Memo

To:	Chris Hanks	Date:	May 11, 2011
Company:	HBML	From:	Kelly Sexsmith
Copy to:		Project #:	1CH008.043.3600
Subject:	Formal SRK Responses to KIA Requests

SRK has prepared this memo in response to questions and comments by the Kitikmeot Inuit Association (KIA) on the "Hope Bay Doris North Waste Rock and Ore Management Plan" dated December 2010. The original comments by KIA and SRKs responses are provided below.

Figure 1: Comparison of sulphur content for infrastructure samples with different amounts of visual pyrite

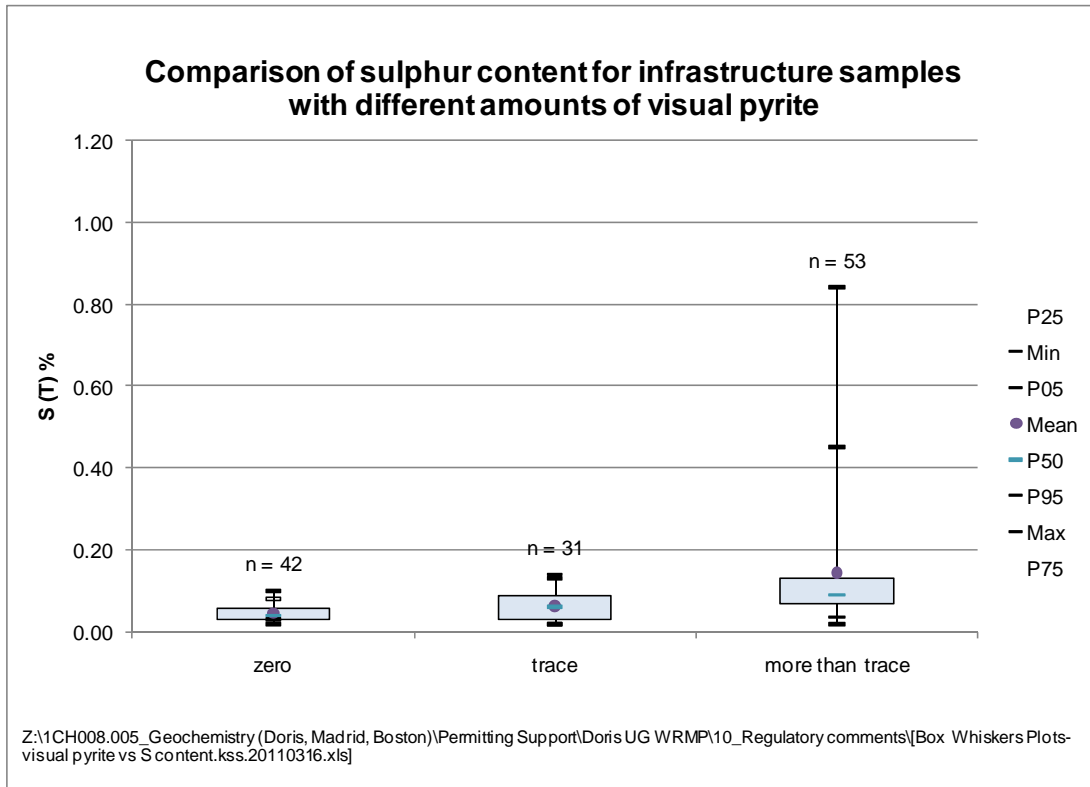
b: Visual inspection has been proposed as the primary screening method for segregating the waste rock into mineralized and non-mineralized storage areas on the pile. The inspection will include both rock type and sulphide content. The geologists have been further instructed to classify rock as "mineralized" if there are any doubts as to their ability to see or estimate the abundance of sulphides. However, HBML would like to emphasize that samples are also being collected at a minimum frequency of one sample per 5,000 tonnes for acid-base accounting (ABA) testing, with additional samples providing a sampling density of one sample per 1,000 tonnes for total inorganic carbon (TIC) and total sulphur content in units that have a higher degree of variability such as basalt or alteration zone material. The final destination of these materials in the dump is also being tracked so that the laboratory results can be directly tied to specific locations within the non-mineralized area of the pile.

The assumption that visual methods would be an appropriate means of segregating the rock is based on correlations between observations of sulphides in the geological logs and corresponding test results in data from recent construction characterization programs (SRK 2010a-d) in which the site geologists were asked to pay particular attention to the visual estimates. As shown in Figure 1, samples with higher sulphur values based on laboratory testing corresponded to observations of more than trace amounts of pyrite.
